CONTEMPLATED CHANGE NOTICE

CCN NO: **07**
 CONTRACTOR: **Mr. Pat Newton**
Talco Building Innovations Inc.
 4728 Bank Street
 Ottawa ON K1T 3W7

PROJECT NAME: **225 Huntmar**
Ottawa, Ontario

PROJECT NO: 15-010
 DATE: 2020, April 20

SK-14

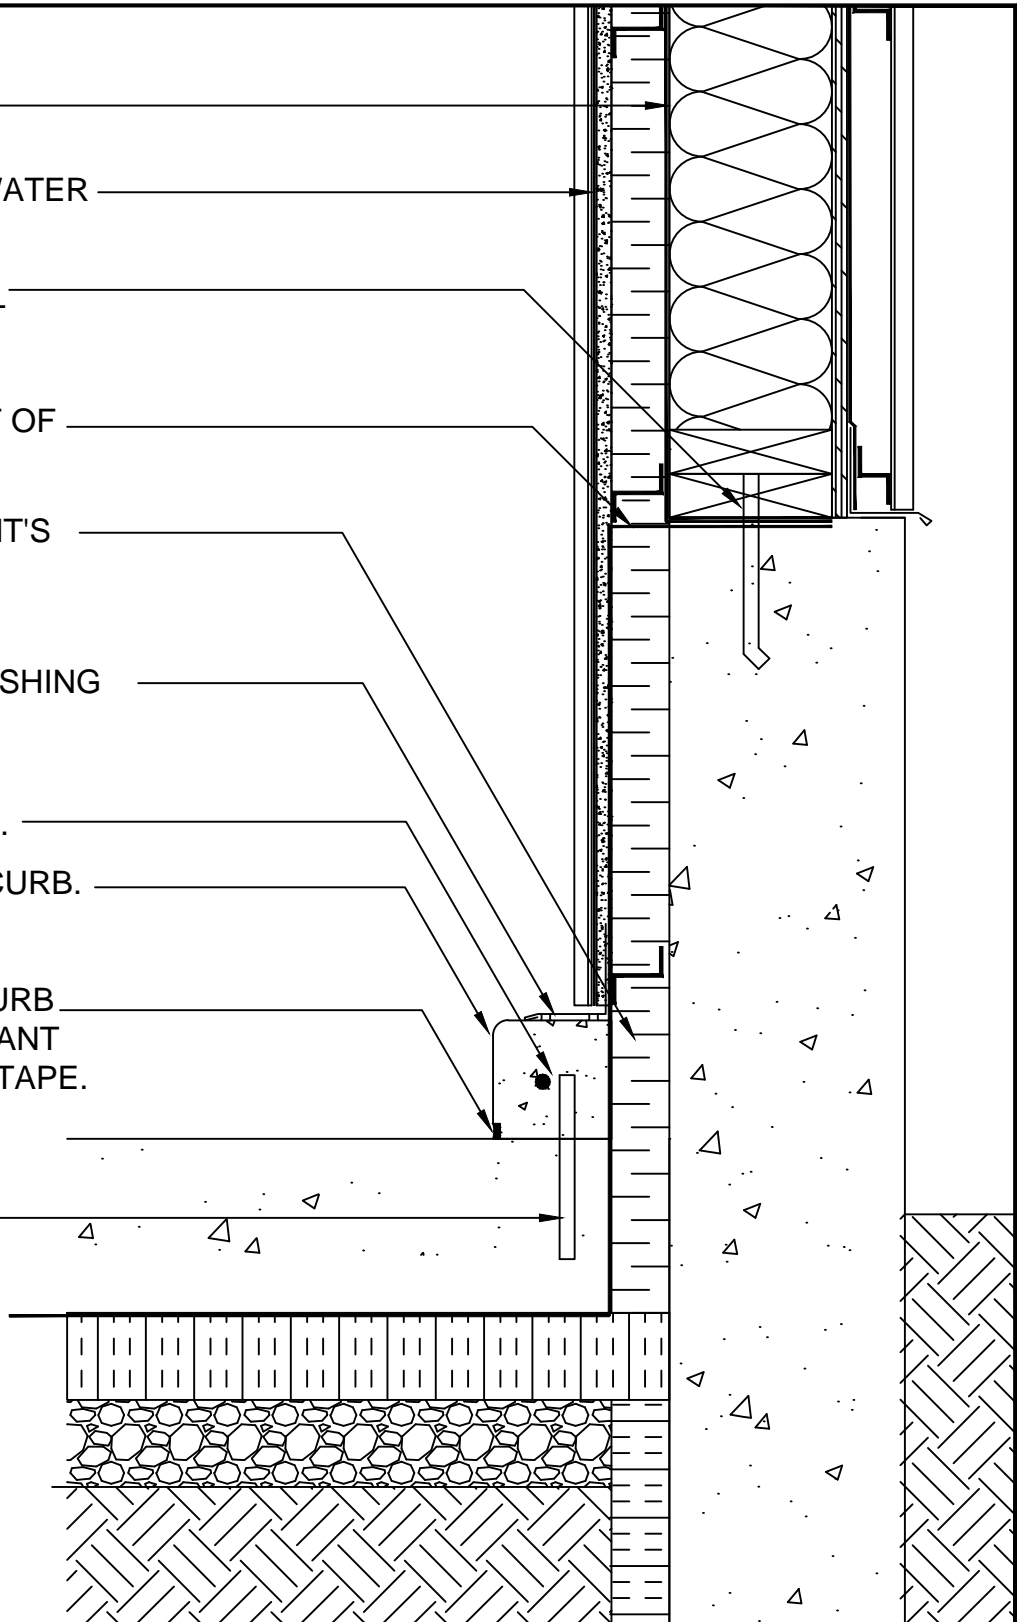
1. Further to Contractor's Information Request #13, and drawings 2/A400. Please provide pricing for the following modifications to the foundation wall insulation:
 - .1 Provide 102mm x 1202mm concrete curb at full perimeter of each wash bay, per attached SK-14

50 MM RIGID INSULATION CONT'S BEHIND CURB.

BED PREFINISHED METAL FLASHING IN TWO CONT'S BEADS OF SEALANT.

1-10M CONT'S HORIZ. IN CURB.

13MM MITRE AT CORNER OF CURB.

FORM REBATE AT BASE OF CURB AND SEAL WITH CONT'S SEALANT JOINT WITH BOND BREAKING TAPE.

DOWEL TO SLAB.
